CHANGE ORDER

No. One (1)

Project: Barber Road Bank Stabilization

WORK CHANGE DIRECTIVE

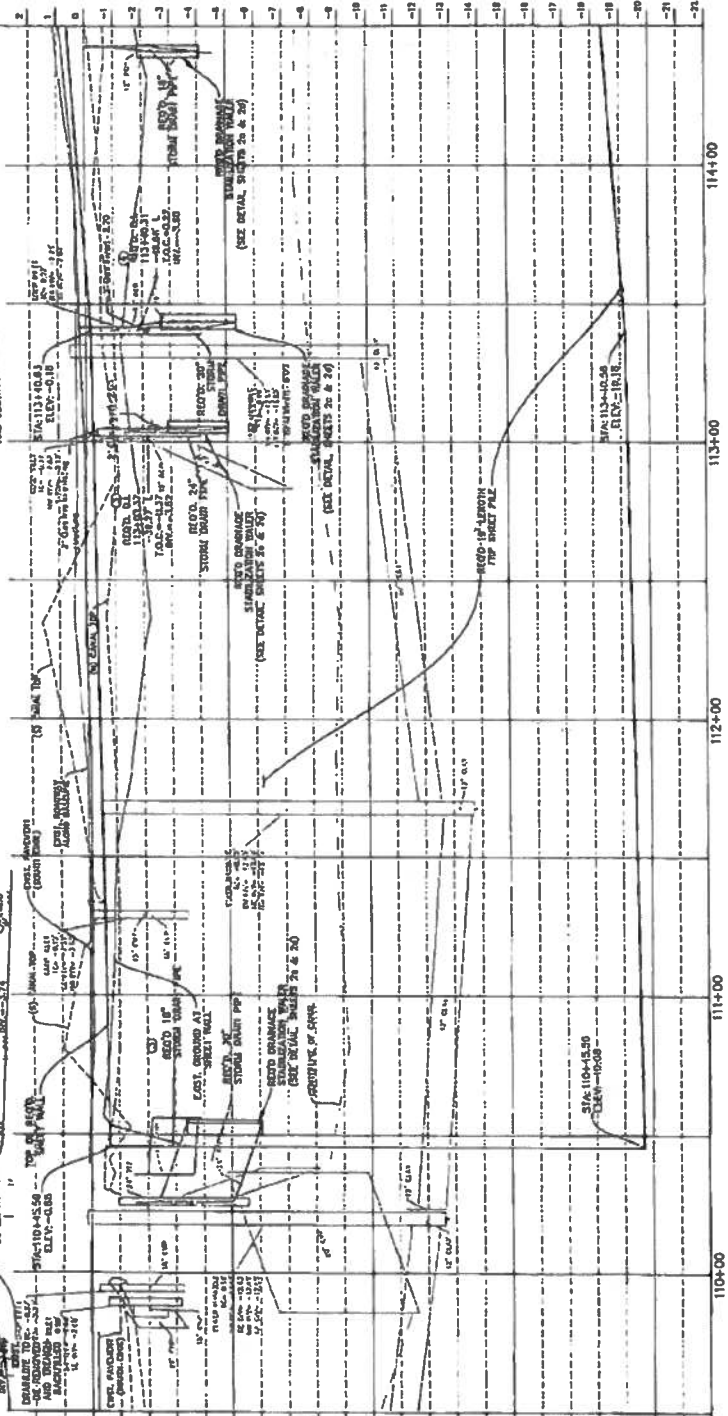
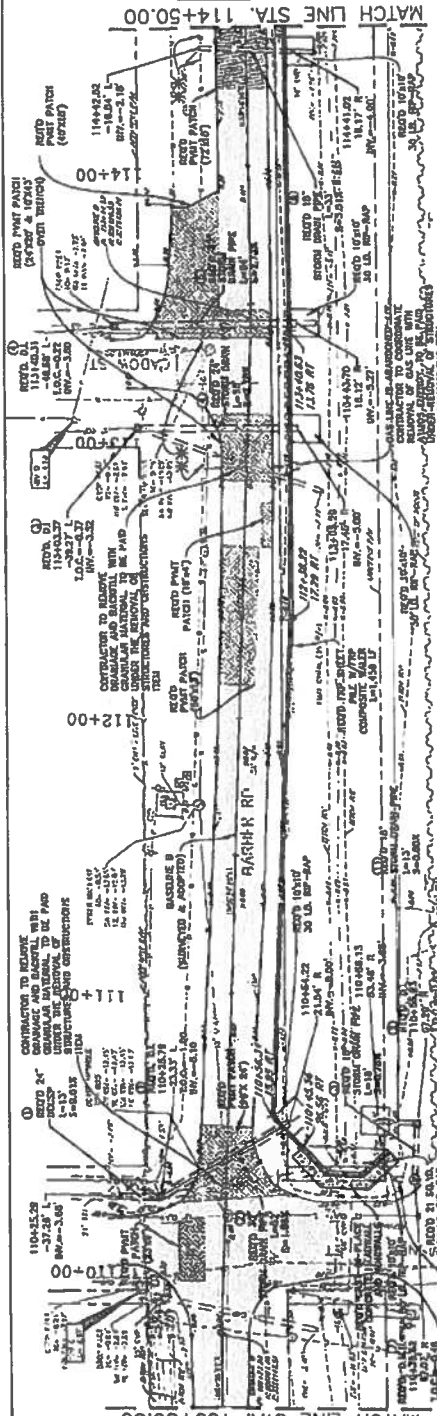
In reference to RFI 05, at Sta. 118+08, Command has been authorized to perform a SFM offset on the known SFM conflict and a second offset on the second SFM beneath the roadway, if confirmed to be in conflict. Please confirm second offset with SCP and RCLC as soon as exposed. SFM offsets to be paid under item TS-741-10009 - 8" WATER LINE OFFSET item for 6", 8", or 12" SFM offsets.

State Project No.: P210702	RFI Number: 5
Project Name: Barber Road Bank Stabilization	Date Received: 10/11/2023
Project Manager: Arthur Ledet	Date Required: 10/12/2023
Project Engineer: Frank Zemmer	Forwarded To:
Contractor: Command Construction, LLC	Date Responded: 10/11/2023
Specification No.:	Page No.:
check one: <input checked="" type="checkbox"/> RFI	<input type="checkbox"/> Design Modification
check one: <input type="checkbox"/> Standard Specification	<input type="checkbox"/> Supplemental Specification
	<input type="checkbox"/> Proposed VE
	<input type="checkbox"/> Special Provision
Plan Sheet No.: .7 thru 9	Detail:
REQUEST: While performing exploratory excavation, Command found numerous conflicts with our new drain line, including the gas and SFM's. Please see the attached redline drawings showing the conflicts from our findings highlighted in yellow.	
PROPOSED SOLUTION (If applicable): Engineer to advise Command on a proposed solution.

By: Bradley Cieslinski	Signature: <i>Bradley Ciestinski</i>
	Date: 10/11/2023
RESPONSE: Please provide horizontal locations on plan view for SFM. Station 113+03.37 drainage has been relocated through RFI#2 and should no longer be in conflict. It appears from the redlines on the drawings that the gas lines are above the drainage and not in conflict. Once RCLC has the horizontal SFM information, we can respond in detail to the remaining conflicts mentioned in this RFI.	
By: Angela Eymard, PE	Signature: <i>Angela Eymard</i>
	Date: 10/11/2023
After reviewing the response, does the contractor anticipate:	
That a change order will be required? <input type="checkbox"/> Yes	<input checked="" type="checkbox"/> No
That there will be an increase in the cost of the project? <input type="checkbox"/> Yes	<input checked="" type="checkbox"/> NO

Pages 2&3 - RFI 12
Page 4 - 12/12/23 Inspector Photos from exploratory excavations
Page 5 - Mark-up plan sheet 8 (Sta. 116+50)

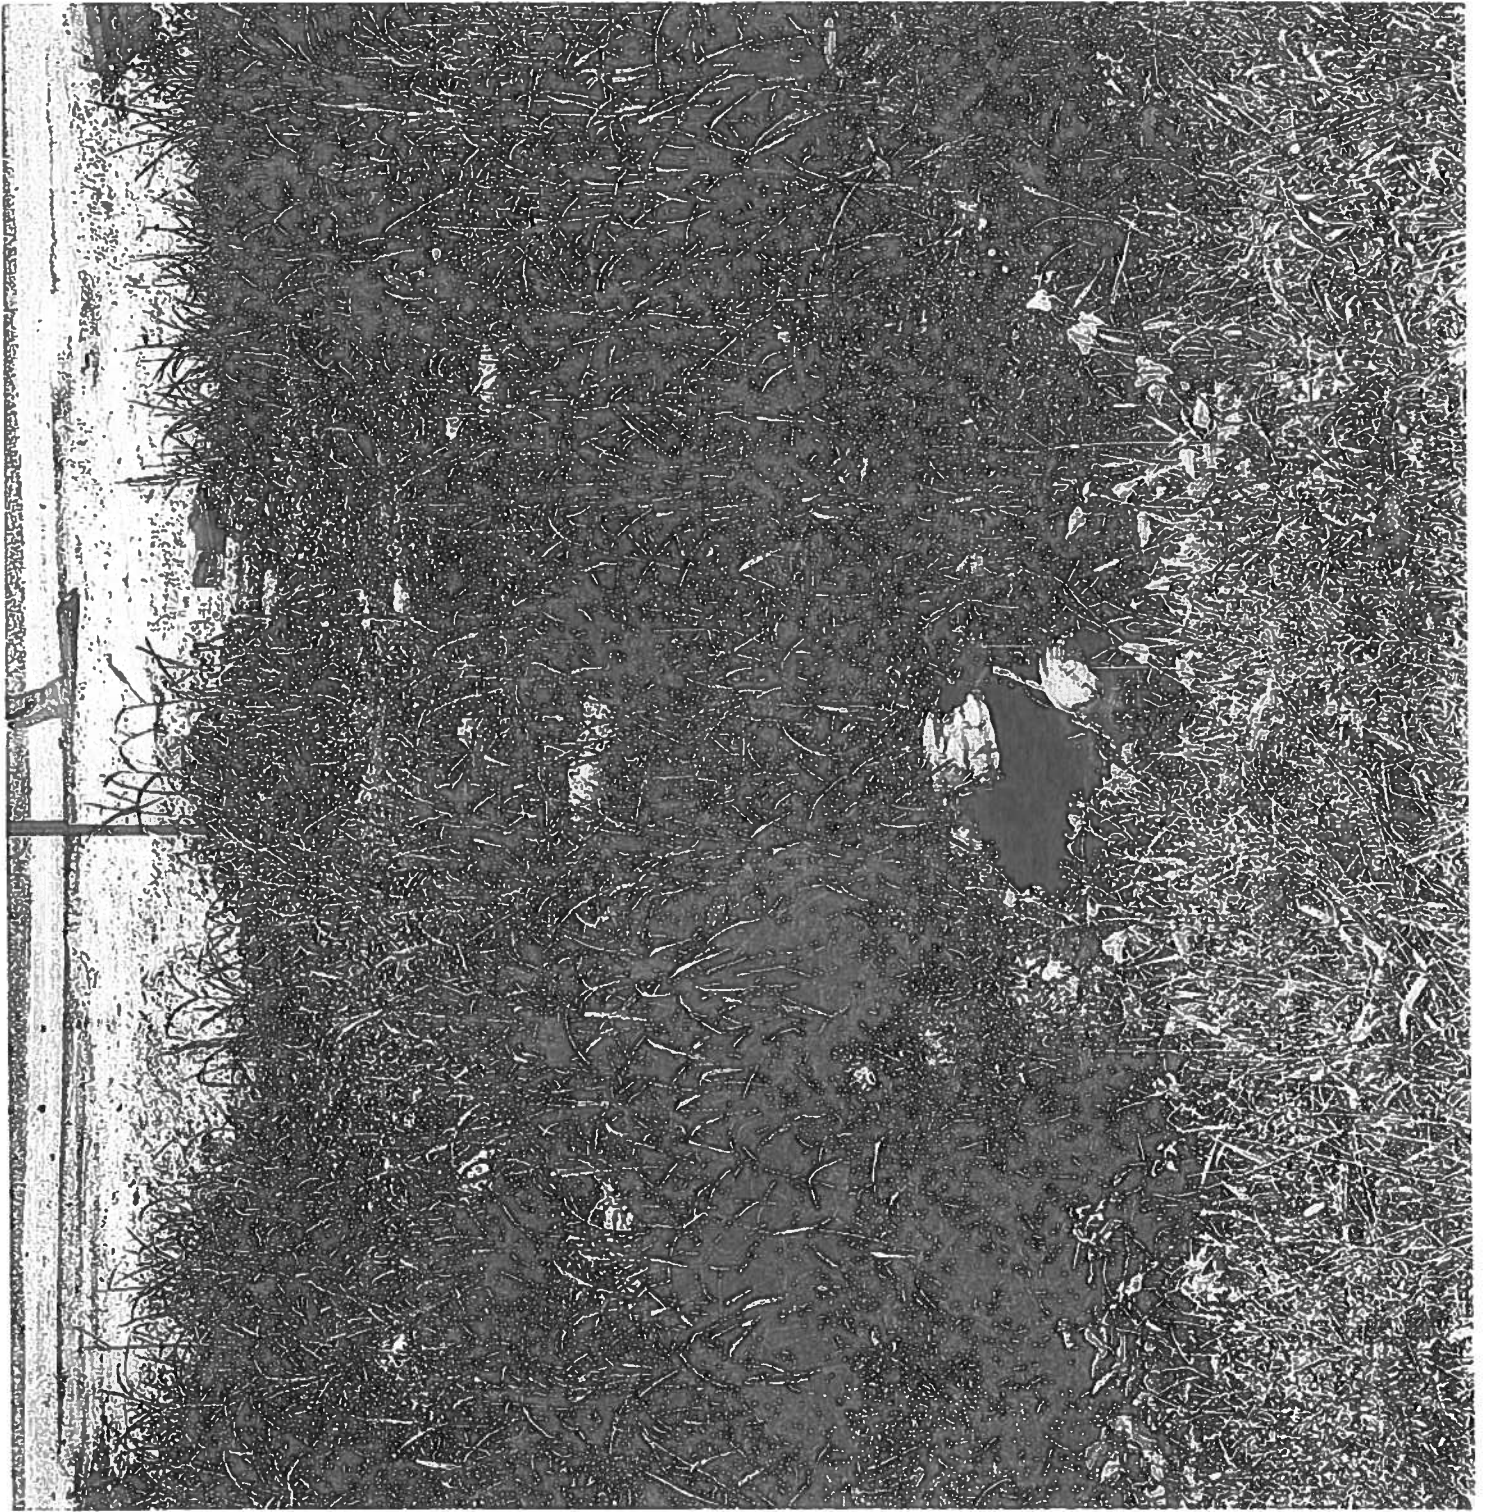
In reference to RFI 12, install new Drain Inlet and replace existing 36" CMP with 30" Storm Drain Pipe CPPPDW. Utilize D.I. #4 and adjust top of box to facilitate proper drainage to casting and grate. D.I. adjustment to be paid under Item 702-04-00200 ADJUSTING DRAIN INLETS. 6' x 18' PAVEMENT PATCHING, 10' x 10' RIP RAP and DRAINAGE STABILIZATION WALER to be paid under existing contract items.

State Project No.: P210702	RFI Number: 12
Project Name: Barber Road Bank Stabilization	Date Received: 12/4/2023
Project Manager: Arthur Ledet	Date Required: 12/5/2023
Project Engineer: Frank Zemmer	Forwarded To:
Contractor: Command Construction, LLC	Date Responded:
Specification No.:	Page No.:
check one: <input checked="" type="checkbox"/> RFI	<input type="checkbox"/> Design Modification
check one: <input type="checkbox"/> Standard Specification	<input type="checkbox"/> Supplemental Specification
	<input type="checkbox"/> Proposed VE
	<input type="checkbox"/> Special Provision
Plan Sheet No.: 9	Detail:
REQUEST:	
At approximately STA 116+50 we found the buried drain line as well as the box it tied into which is 11' from edge of road. The invert at the box is -7.81' with a TOC of -3.6'. At the outfall, the invert is -7.9'. The pipe is a 36" CMP and is 43' long.	
PROPOSED SOLUTION (If applicable):

1. We do not have a pay item for 36" CMP. Command can submit a change order price to replace this with 36" CMP which has a 2-3 week lead time and would request days back on the contract.

2. We can order 36" (CPPPDW) which has a 5-7 day lead time and would request days back on the contract. Only comes in 20' joints so would get paid for 60'.	
By: Bradley Cieslinski	Signature: <i>Bradley Cieslinski</i>
	Date: 12/4/2023

Page 5 - Mark-up plan sheet 9 (Sta. 121+00)

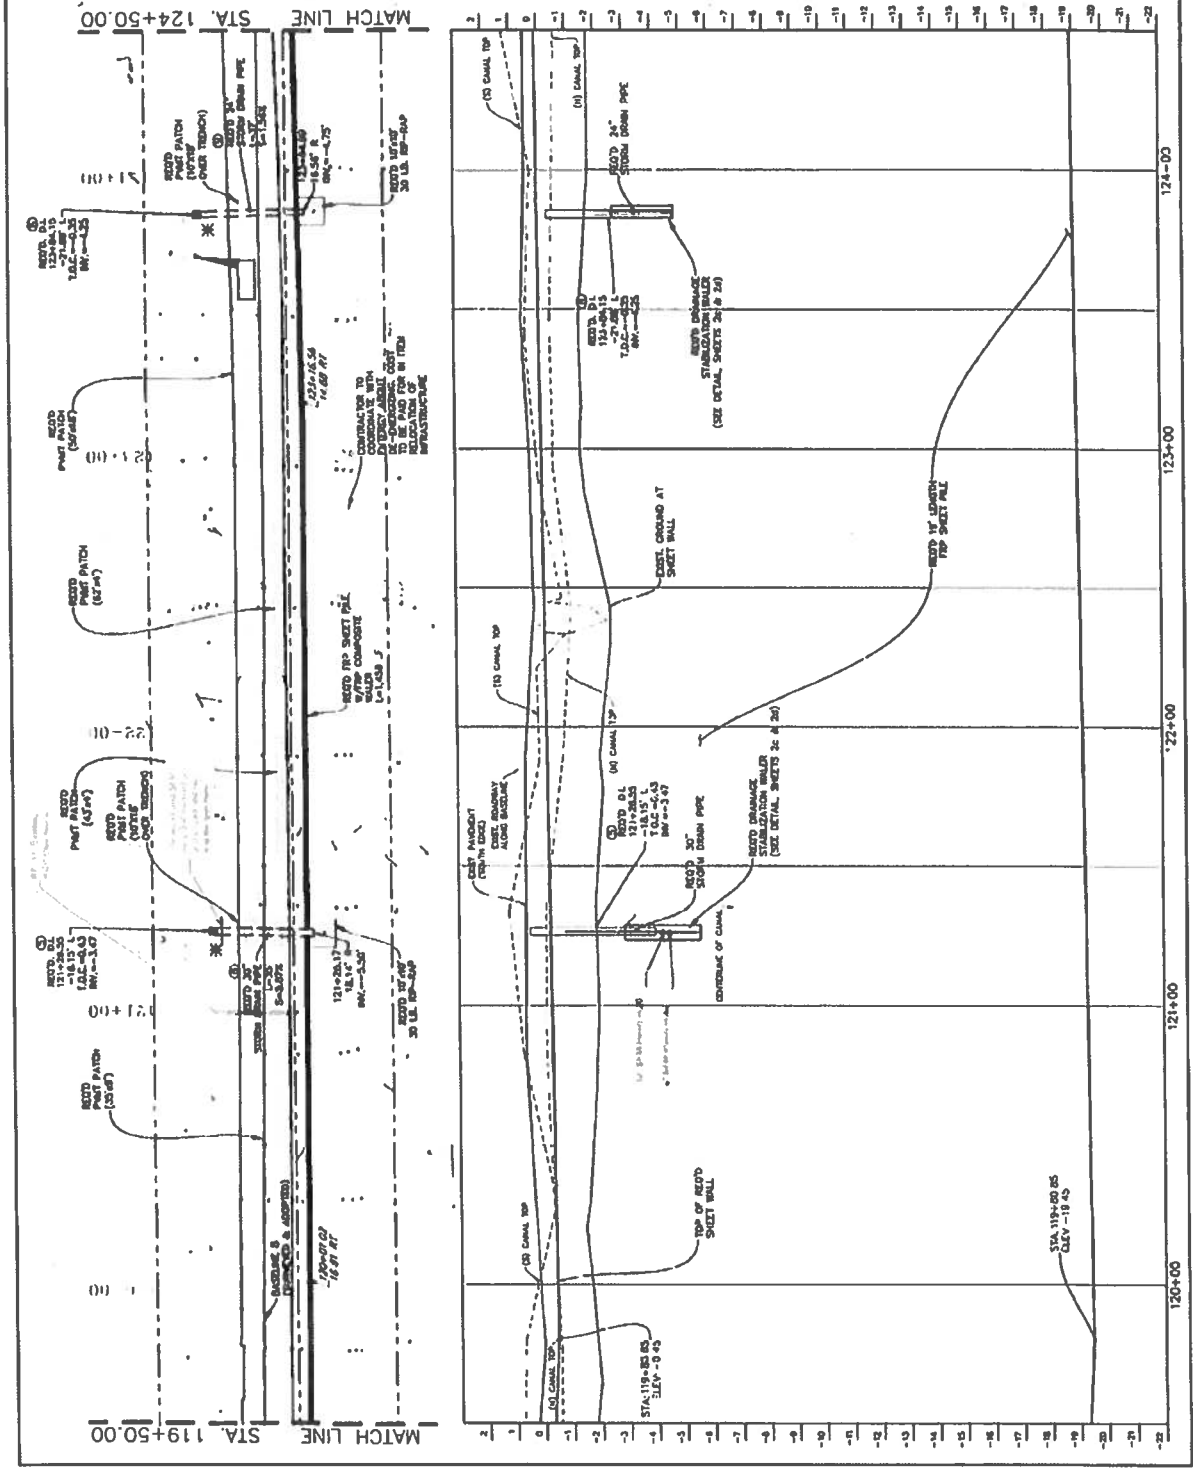
Description: Enter description of changes for Contractor.
In reference to RFI 11, replace existing 15" CMP with 18" Storm Drain Pipe CPPPDW Adjust top of existing box to driveway elevation with closed top cover D.I adjustment to be paid under Item 702-04-00200 ADJUSTING DRAIN INLETS. 6' x 18' PAVEMENT PATCHING, 10' x 10' RIP RAP and DRAINAGE STABILIZATION WALER to be paid under existing contract items. Command to submit pricing for R/R concrete Driveway.

Page 5 - Mark-up plan sheet 9 (Sta. 121+26)

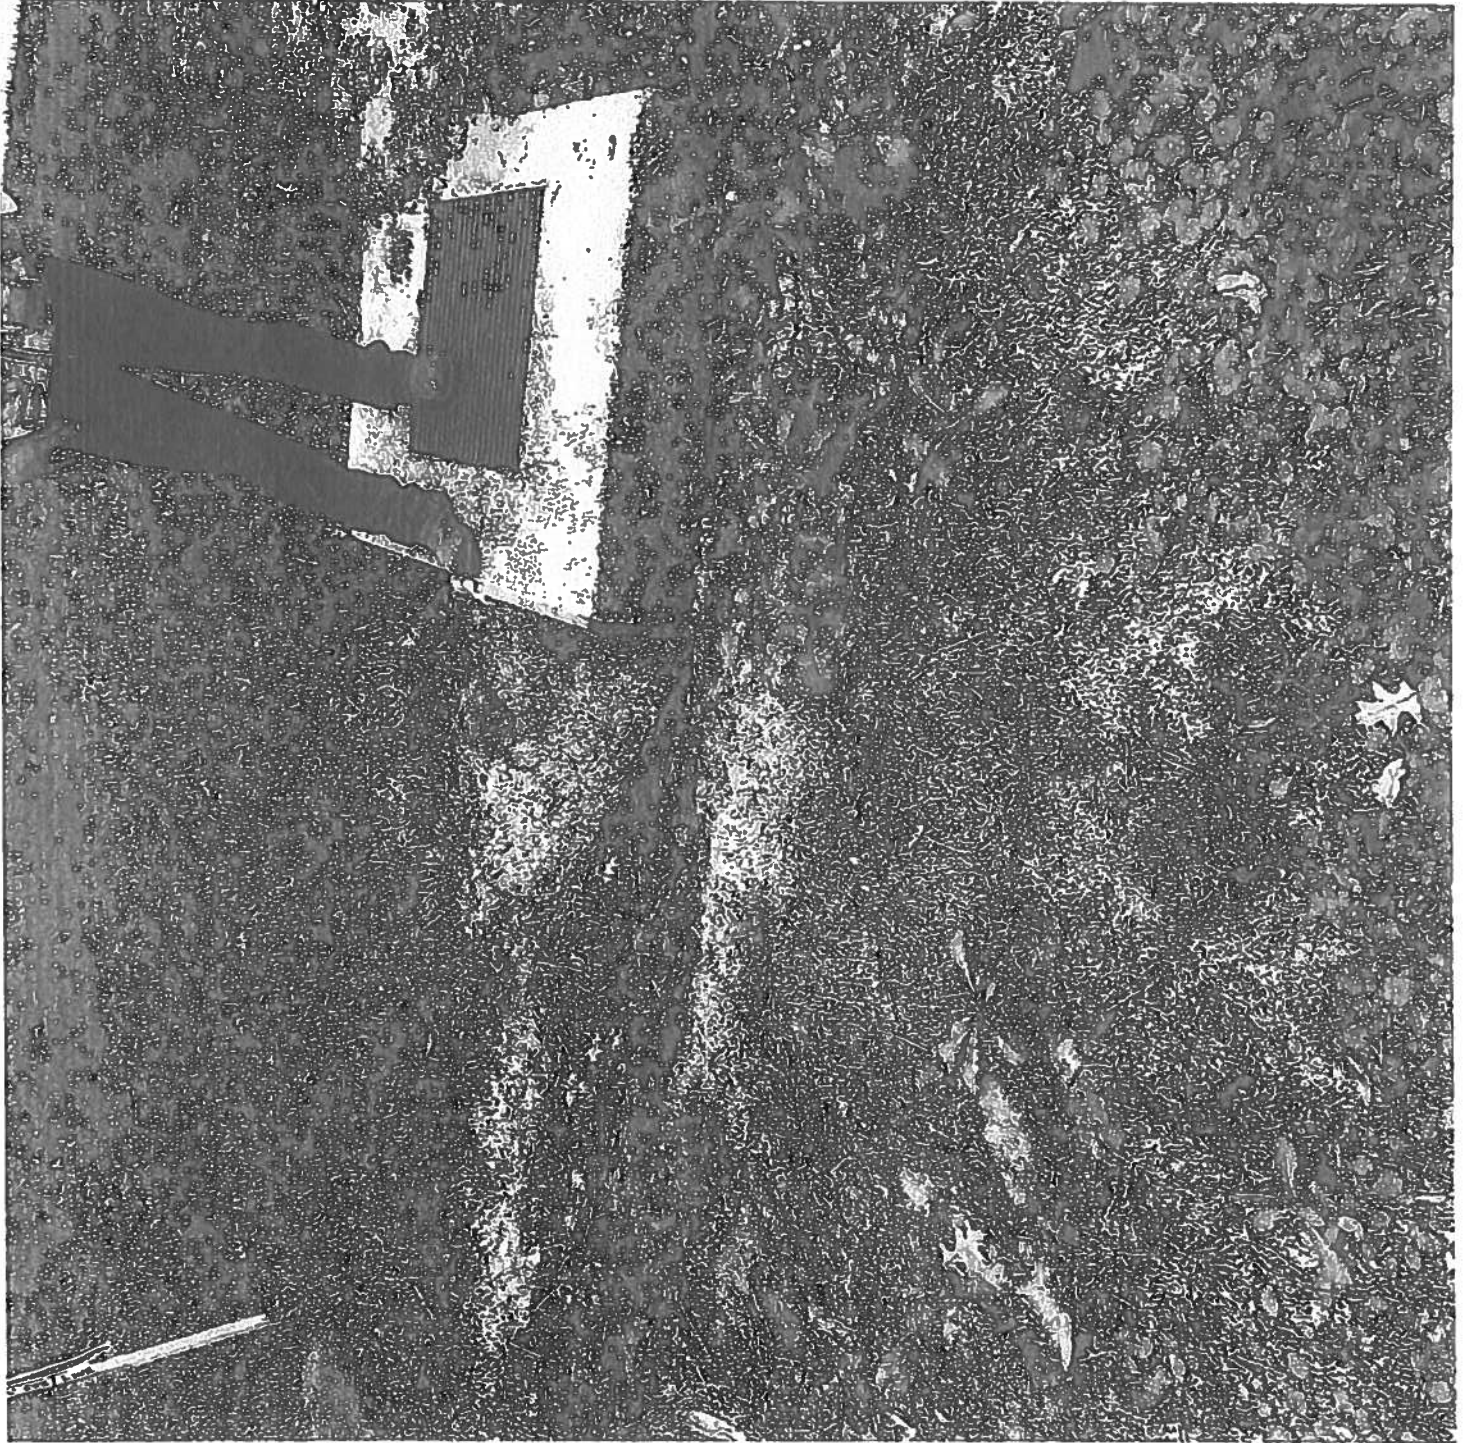
In reference to RFI 10, replace existing 24" CMP with 24" Storm Drain Pipe CPPPDW. Adjust top of D.I. #5 to facilitate proper drainage to grate. D.I. adjustment to be paid under Item 702-04-00200 ADJUSTING DRAIN INLETS.

State Project No.: P210702	RFI Number: 10
Project Name: Barber Road Bank Stabilization	Date Received: 12/4/2023
Project Manager: Arthur Ledet	Date Required: 12/5/2023
Project Engineer: Frank Zemmer	Forwarded To:
Contractor: Command Construction, LLC	Date Responded:
Specification No.:	Page No.:
check one: <input checked="" type="checkbox"/> RFI	<input type="checkbox"/> Design Modification
check one: <input type="checkbox"/> Standard Specification	<input type="checkbox"/> Supplemental Specification
	<input type="checkbox"/> Proposed VE Special Provision
Plan Sheet No.: 9	Detail:
REQUEST:	
At STA 121+26 where DI#5 is to be placed, there is a swale along the property line that drains towards this DI. The TOC of the existing DI and the new DI are the same @ -.43'. Currently, the swale does not drain into grating as the grating is higher than the bottom of the swale. In the exiting DI there is a hole cut in it to let water flow into the box.

PROPOSED SOLUTION (If applicable):	
Engineer to direct Command on how they want us to proceed with getting water from the yard to the DI.	
By: Bradley Cieslinski	Signature: <i>Bradley Cieslinski</i>
	Date: 12/4/2023
